PCN #	455	Notification Date:	03/08/2022
-------	-----	--------------------	------------

Title:	Terminal out of specification (88090 & 88608).		
--------	--	--	--

Product / Process Change Notification (PCN)

Honeywell Juarez Optoelectronica

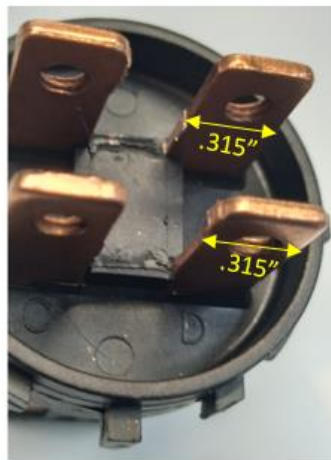
Terminal is out of specification.

According to the drawing of the raw material the width must measure $.300 \pm .005$, however, it measures $.312''$, $.314''$, $.315''$ and creates a burr on the edges.

The drawing of the final product does not indicate these dimensions, and according to the installation information they would not affect the installation or function of the final product.

Due to there are not terminals within specification available, and the dimensions out of specification do not affect the function of the final product, we are proposing to ship the material as is, while the next lot with the corrections is received.
